# UNITED STATES PATENT AND TRADEMARK OFFICE

10/584,779

Thomas Scherer

<b>Office Action Summary</b>	<b>Application No.</b> 10/584,779	<b>Applicant(s)</b> SCHERER ET AL.	
	<b>Examiner</b> EMMANUEL DUKE	<b>Art Unit</b> 3784

Annotated FIG. 8

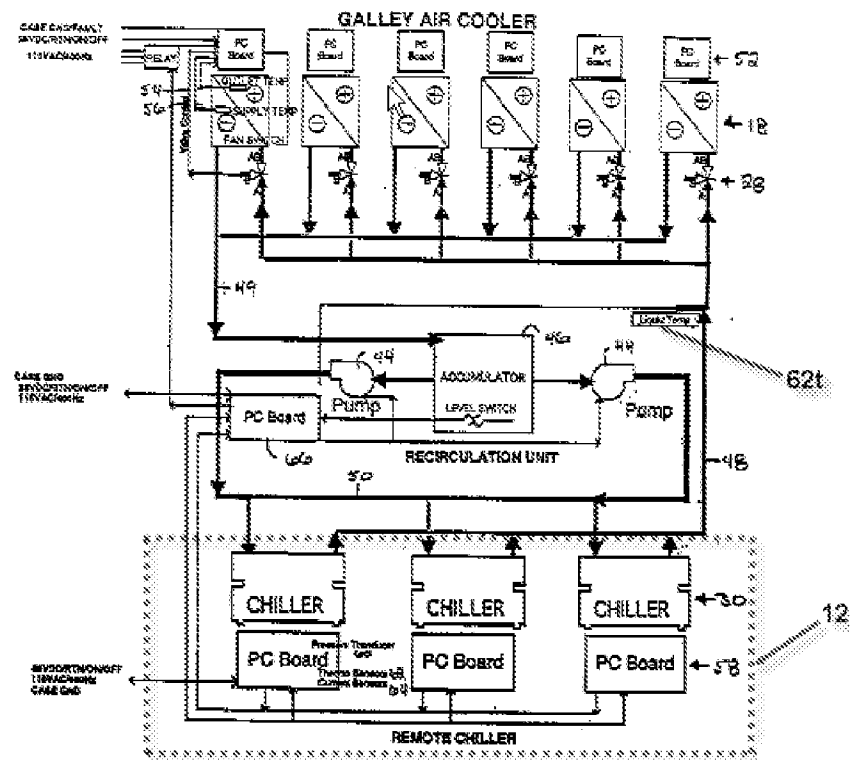
Regarding claim 1, Simadiris et al. ‘361 disclose a cooling system for the cooling of heat producing devices in an aircraft (Fig. 6-8: [0023]), comprising: a cold producing device (see annotated Fig. 8: [0043-0044], wherein 12 constitutes a cold producing device) including at least two cooling machines (Fig. 8: [0043-0044], wherein chiller 30

constitutes a cooling machines) working independently of each other (as shown in Fig. 6-7: wherein the chillers for Door 2 are depicted independently operating from the chillers of Door 4), at least one cold consumer (Fig. 8: [0032], wherein a galley air cooling unit 18 constitute a cold consumer), and a cold conveyance system (Fig. 1-2: [0036-0037], wherein a recirculation/redistribution unit 32 constitute a cold conveyance system) which connects the cold producing device and the at least one cold consumer, whereby the cold conveyance system including at least two cooling circuits completely independent of each other (as shown in Fig. 6-7: wherein the RU 32 for Door 2 are depicted independently operating from the RU 32 of Door 4), the at least two cooling, circuits (48, 49, Fig. 8: [0045]) supplying a cold carrier medium (27, Fig. 8: [0045]) that has been cooled by the cold producing device to the at least one cold consumer and returning the cold carrier medium from the at least one cold consumer to the cold producing device, whereby the at least two cooling machines are coupled in parallel to the cold conveyance system (as shown in Fig. 4: wherein in Door 2, two RC 30 are couple in parallel to the RU 32) such that each of the at least two cooling circuits are thermally coupled (as shown in Fig. 4: wherein in Door 2, lines 48 and 49 are shown thermally coupled) to the at least two cooling machines.

Regarding claim 9, Simadiris et al. '361 disclose the cooling system in accordance with claim 8, wherein at least two cold carrier pumps (as shown in Fig. 8: wherein two cold carrier pumps 44) are assigned to cooling circuit and are supplied with electric energy (Fig. 8: [0049], wherein a control device 66 associated with each RC 32 supplies electric energy) independently of one another.

Regarding claim 18 Simadiris et al. '361 disclose the cooling system in accordance with claim 13, wherein the central control unit records an output (see annotated Fig. 8: wherein in liquid temp 62t constitutes an outlet) temperature of the cold carrier medium leaving the at least two cooling machines and controls the at least two cooling machines in accordance [0049] with the output temperature measured and recorded.
